WORKING DRAFT OF NEC CODE-MAKING **PANEL 4 MEETING OUTPUT**

Document: National Electrical Code®

Revision Cycle: A2025

Panel Activity: Comment Stage

Figure Informational Note 690.1 Illustration of PV System DC Circuits and PV System Components in a Typical PV Installation.

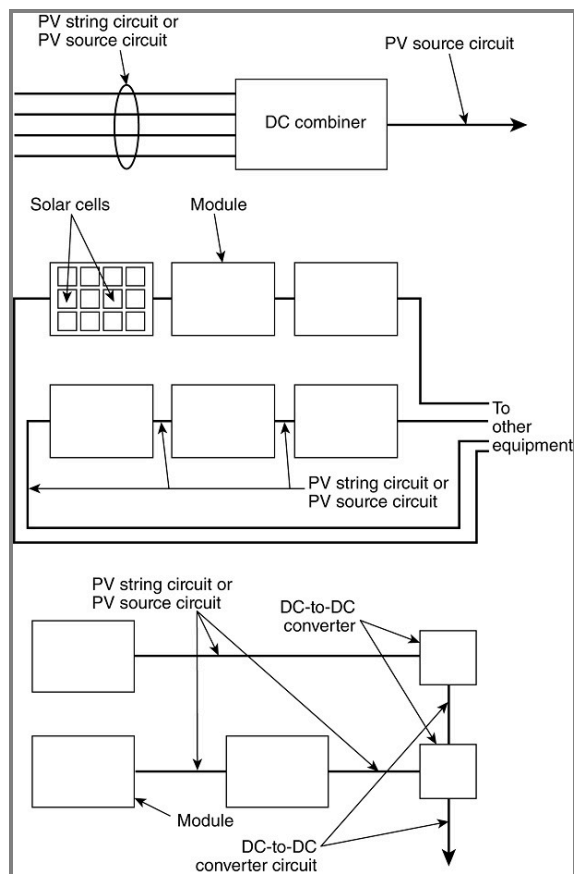
This article applies to solar PV systems, other than those described in 691.4 - than Large-Scale Photovoltaic (PV) Electric Supply Stations. The systems covered by this article include those interactive with other electric power production sources or stand-alone, or both. These PV systems could have ac or dc output for utilization.

Informational Note No. 1: See Figure Informational Note 690.1.

Committee Statement: The scope reference to 691.4 is revised to the title of Article 691, Large-Scale Photovoltaic (PV) Electric Supply Stations, to increase clarity and useability.

Figure Informational Note 705.1 Identification of Power Source Components in Common Configurations.

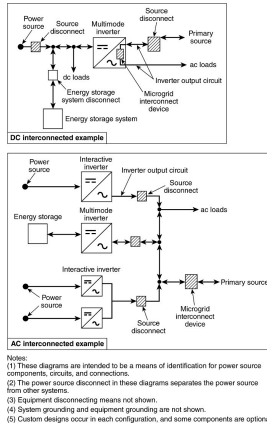
Informational Note No. 2: See Figure Informational Note 705.1.

Committee Statement: The parenthesis (s) is removed from primary source in the scope since the new definition of primary source can be made up of multiple power sources. A microgrid can function as a primary source per the definition in Article 100 and it does not need to be called out in the requirement. The Informational Note No.1 was not consistent with the new definition of primary source so the IN was changed to a simple reference to the Article 100 definition as this change of definition is causing confusion to the users of this Code and needs to be highlighted for at least a few code cycles.
